**ADDENDUM #1
BL040-25
Lester Woods / Woodview Drive Water Main Replacements**

The following addition/changes modify the Bid No. BL040-25 "Lester Woods / Woodview Drive Water Main Replacements" Contract Documents, dated July 2025, as first advertised on July 16, 2025.

NUMBER 1034D

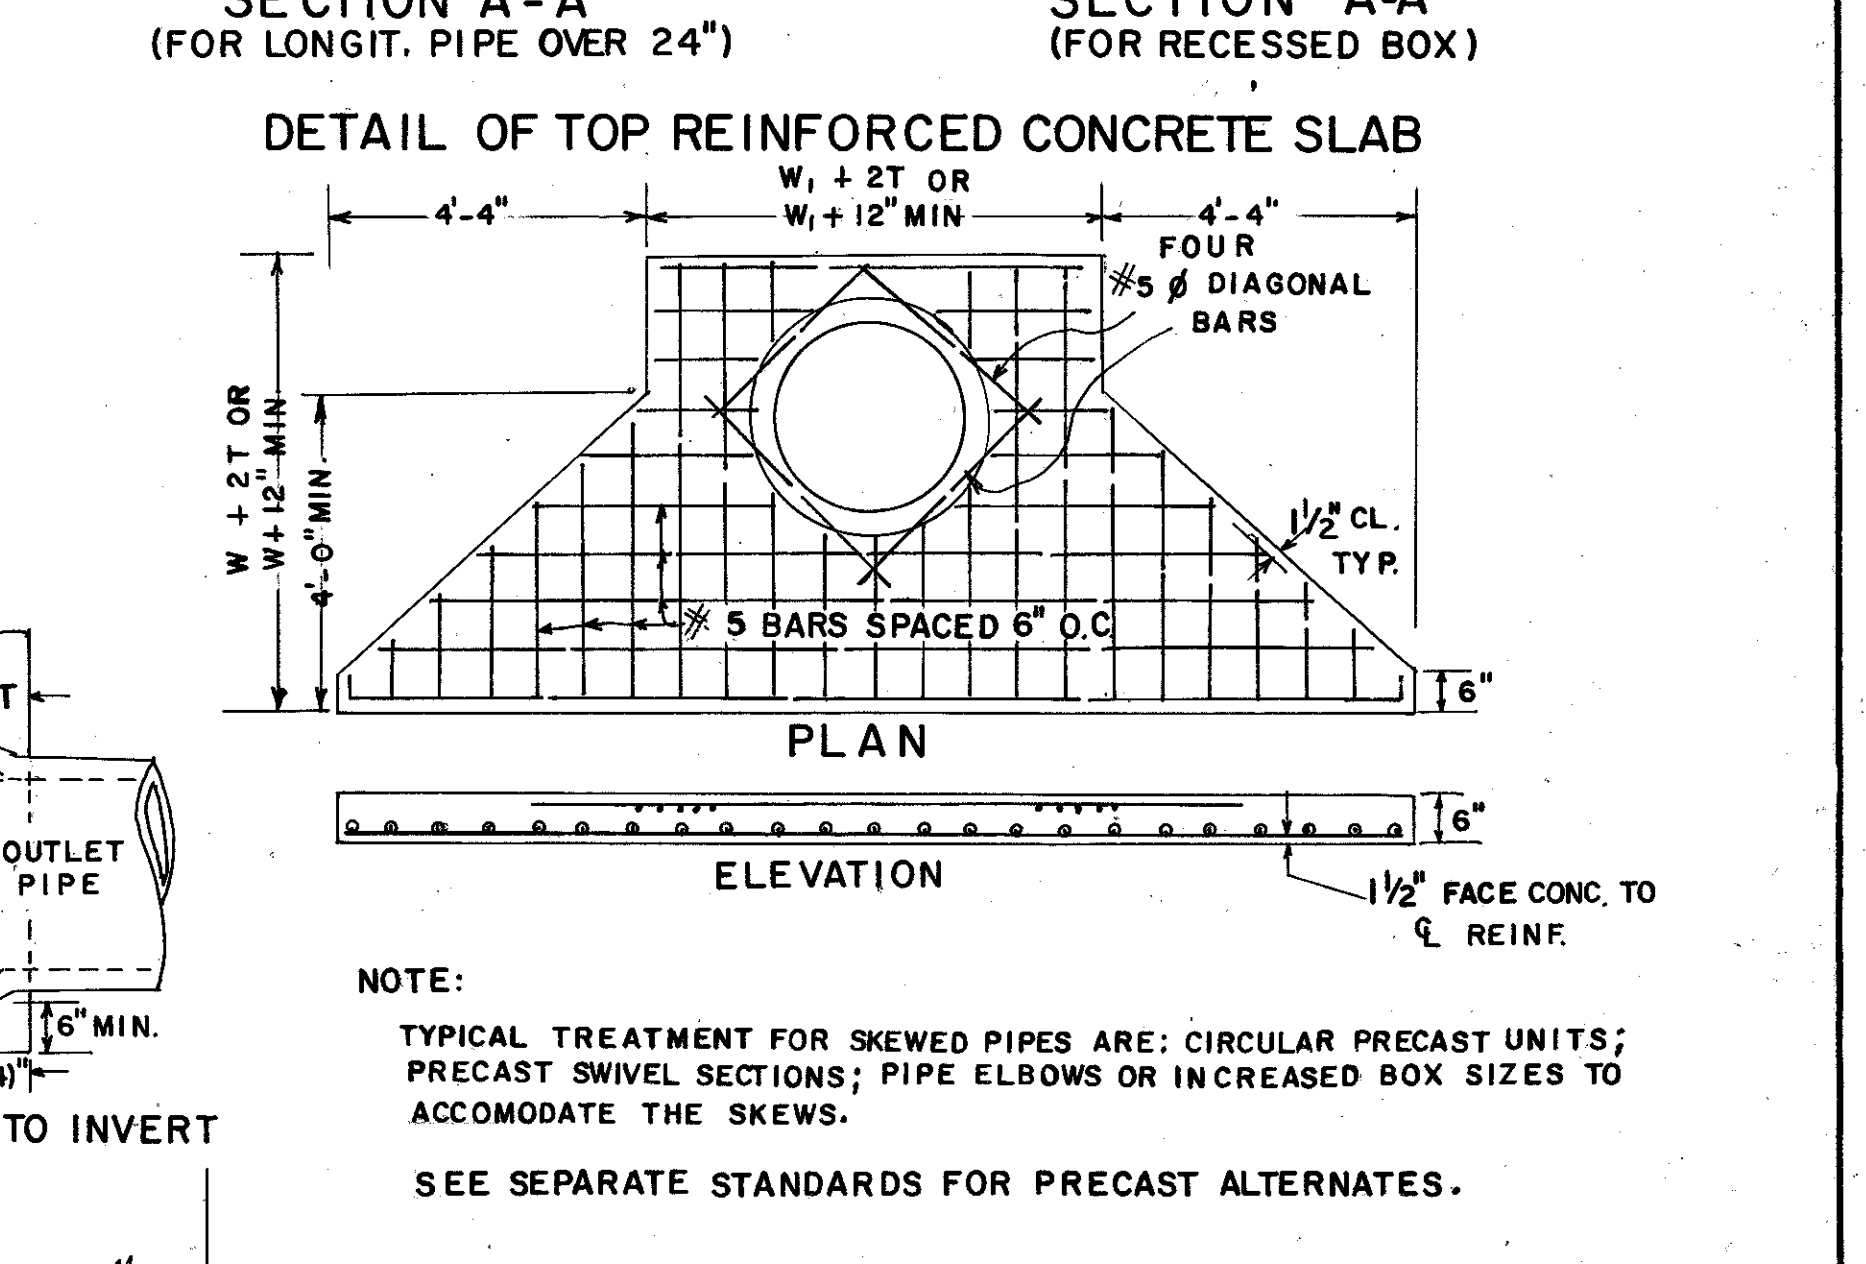
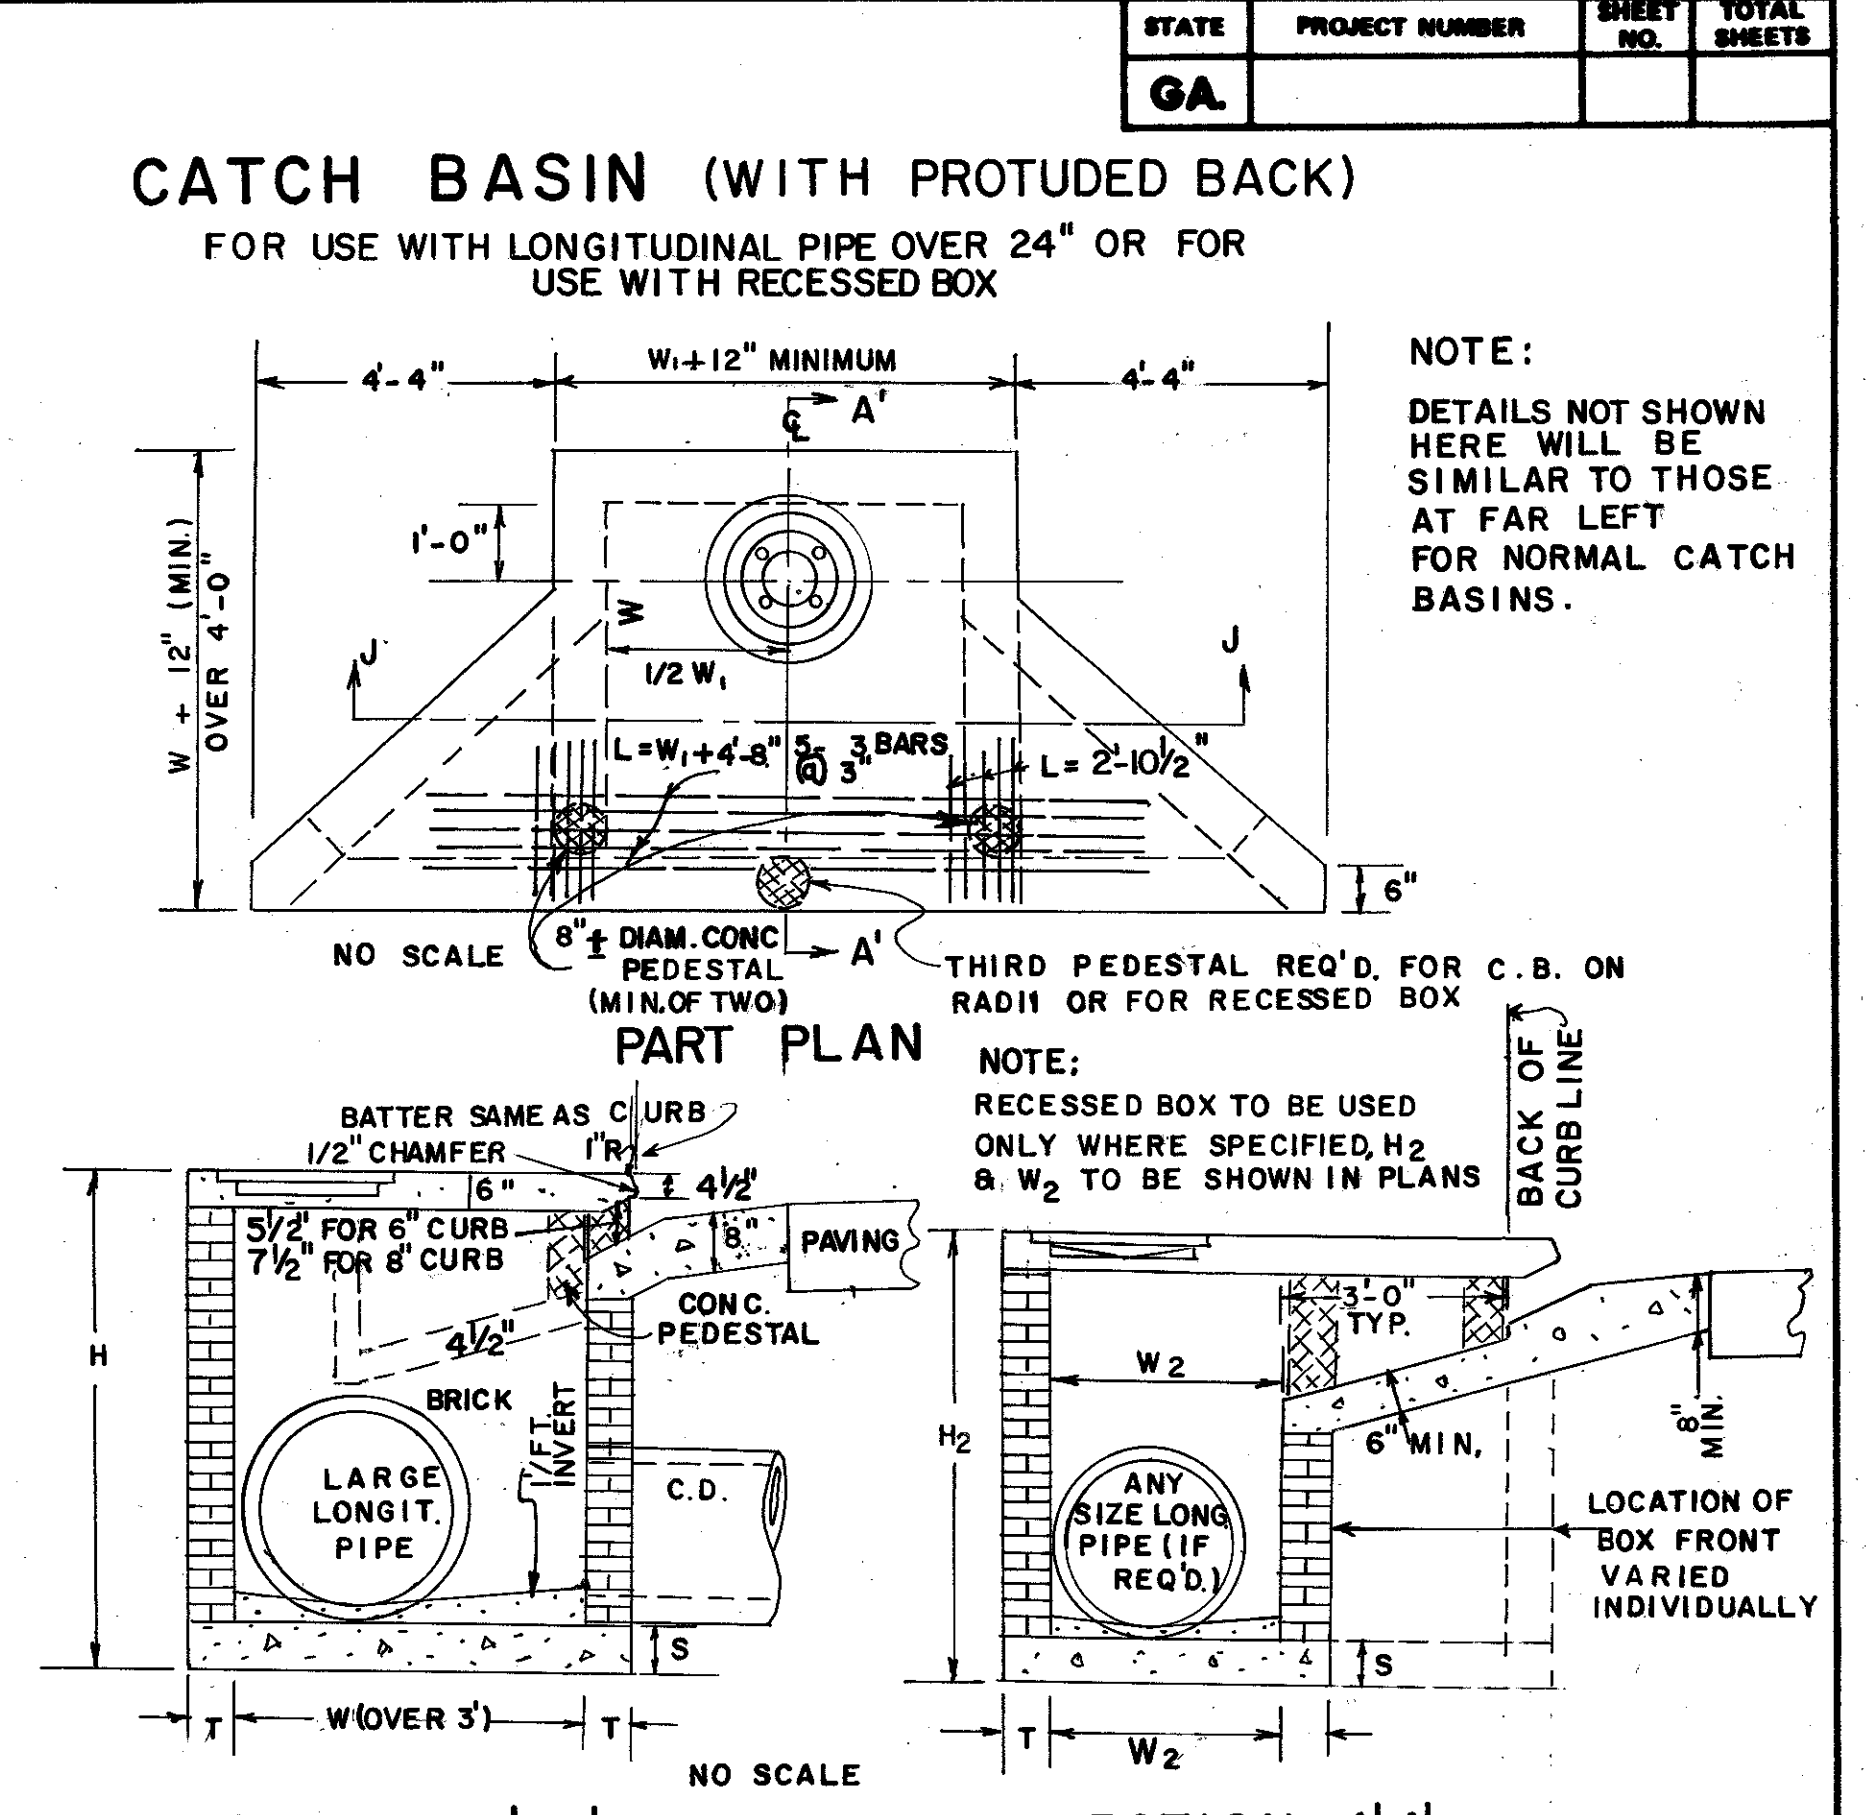
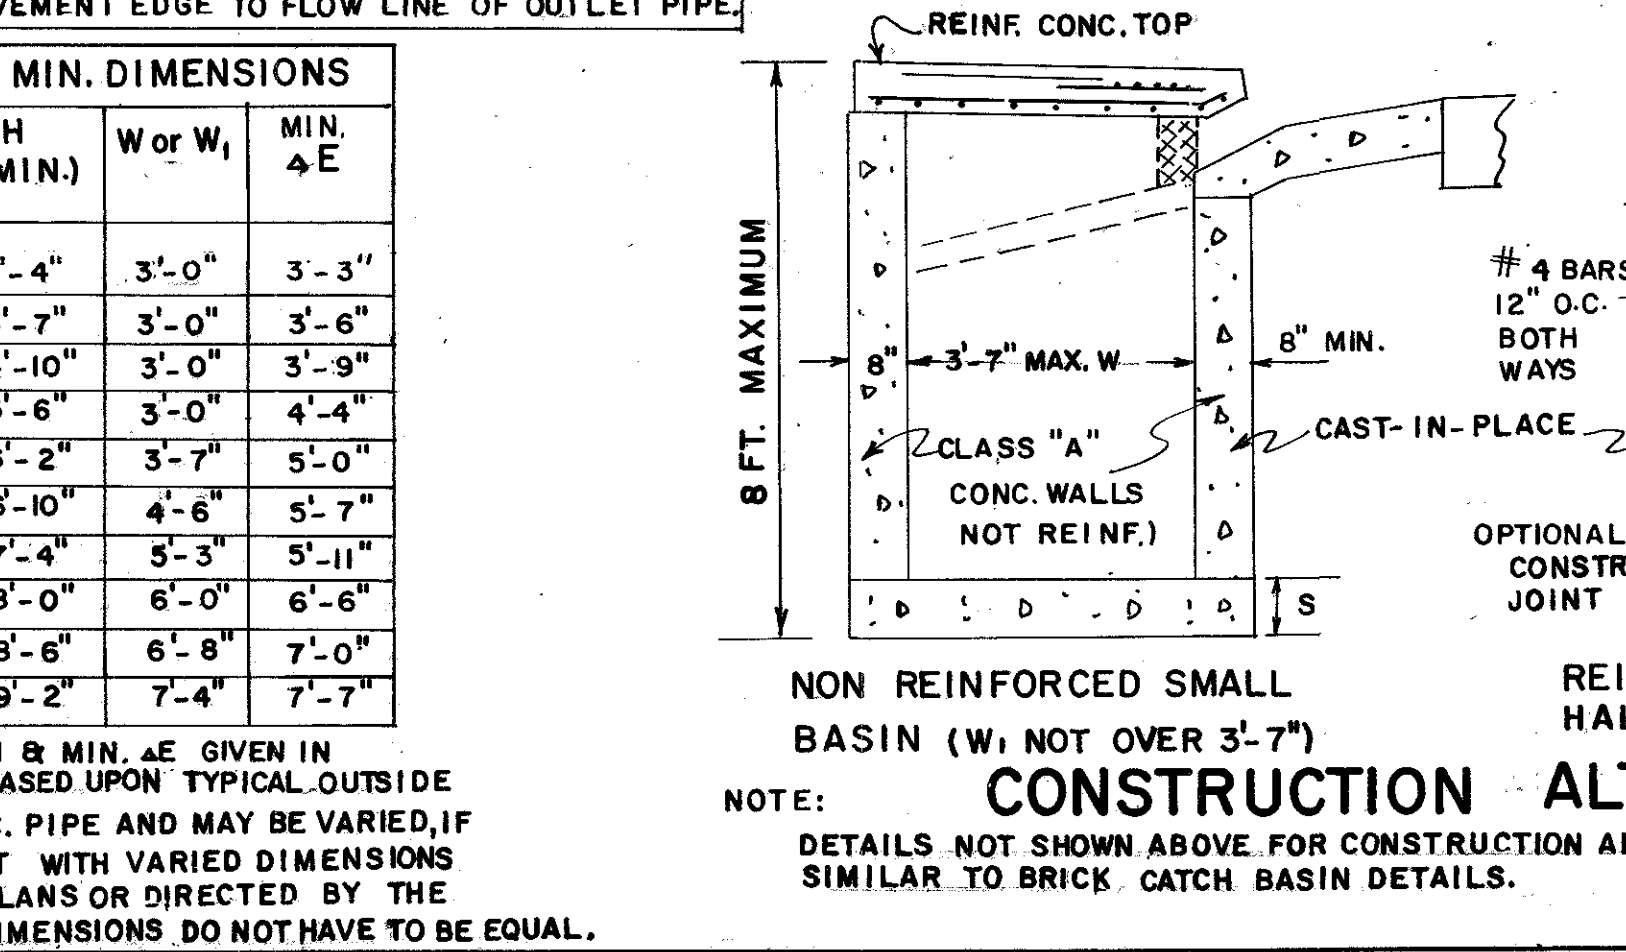
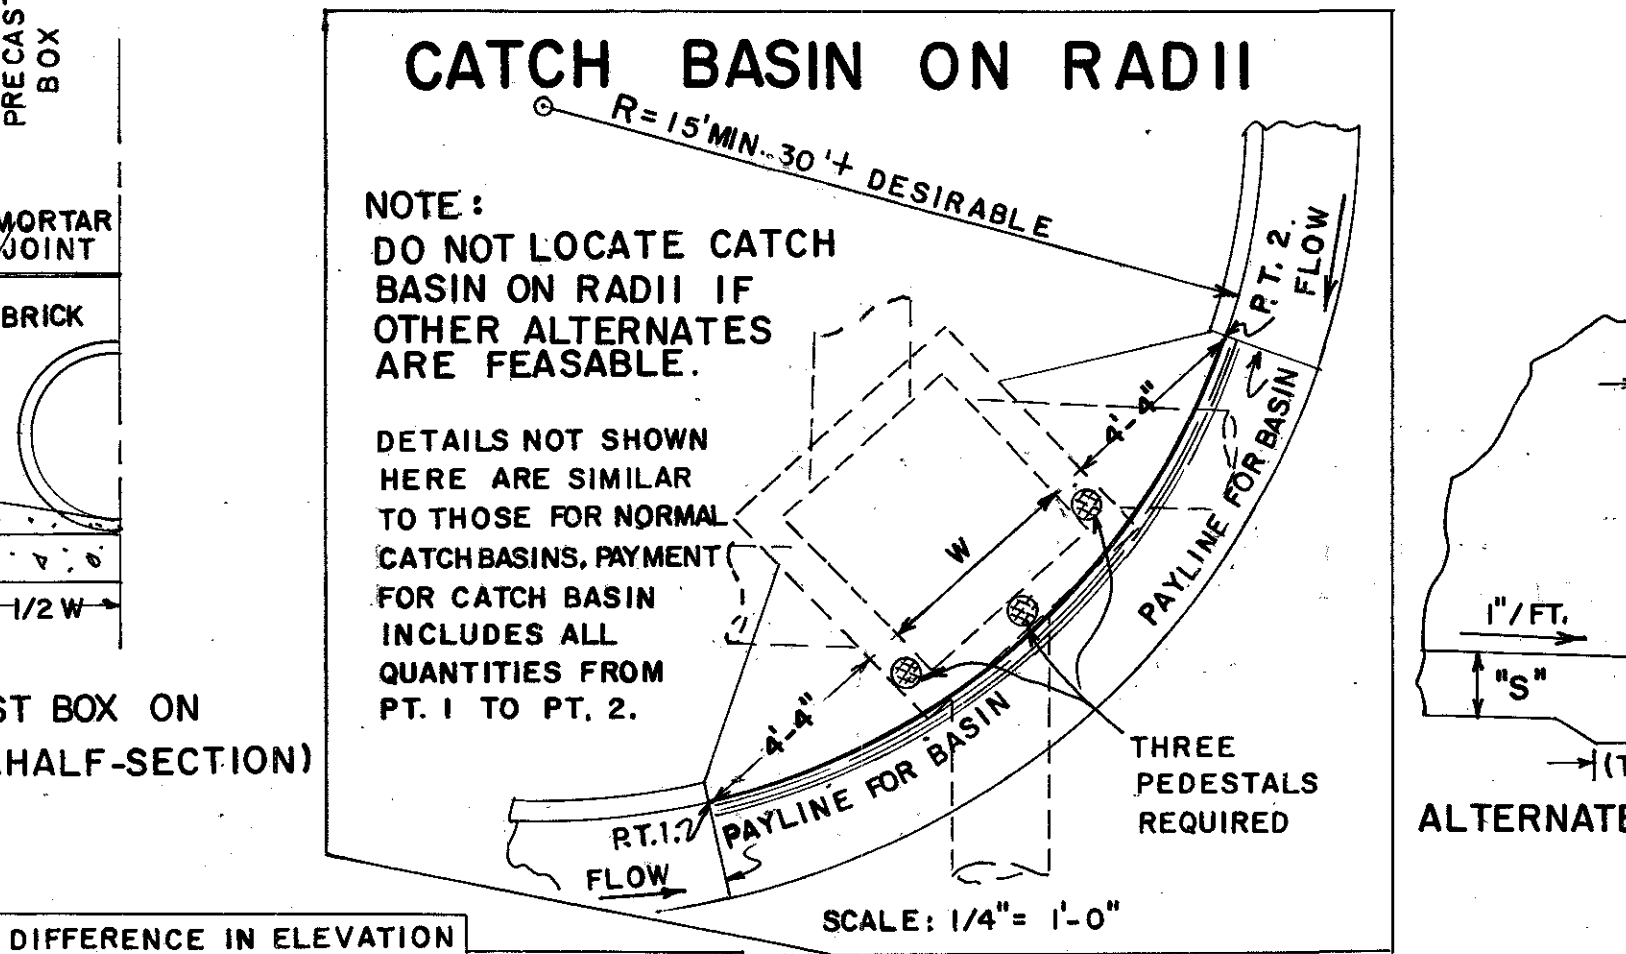
- A8. No, the quantities shown are what the project shall be bid on.
- Q9. Please confirm for bid item 14, that the Catch basins are to be completely removed and replaced with new structures, throats and tops? Can these new structures be bricked up or must they be precast?**

- A9. Please install per GDOT detail 1034D attached.
- Q10. Bid item 19 and 39 are the same for the 16" x 8" Tapping Sleeves and Valves. Is this a mistake?**
